NUMBER 16-47-91

SERVICE BULLETIN

APPLICABILITY ALL LEGACY MODELS EQUIPPED WITH 4EAT

SUBJECT: MANUAL VALVE STOPPER RETROFIT

Figure 3

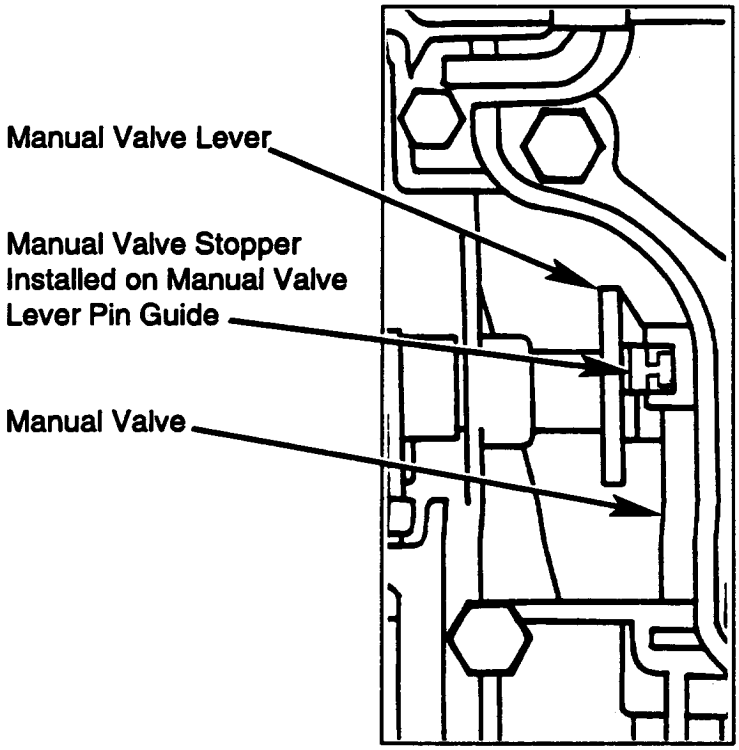
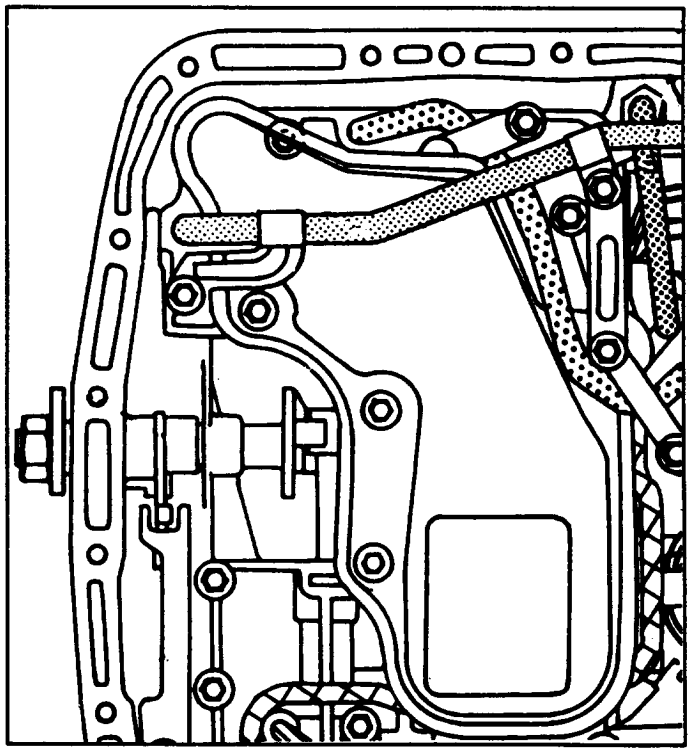
Try to install manual valve stopper P/N 31925AA000 between lever and manual valve. See Figure 3 for illustration.

Stopper cannot be installed due to limited space between lever and valve.

Replace manual valve lever with modified P/N 31935AA012.

Figure 4

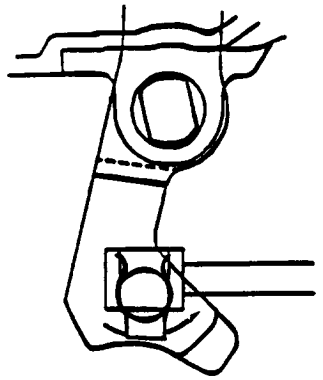
Ensure that at least enough clearance exists between stopper and manual valve to rotate the stopper on the lever guide pin approximately 1-2mm.

NOTE: IF THERE IS NO PLAY BETWEEN STOPPER AND MANUAL VALVE, IT MAY CAUSE PREMATURE WEAR OR BINDING OF MANUAL VALVE.
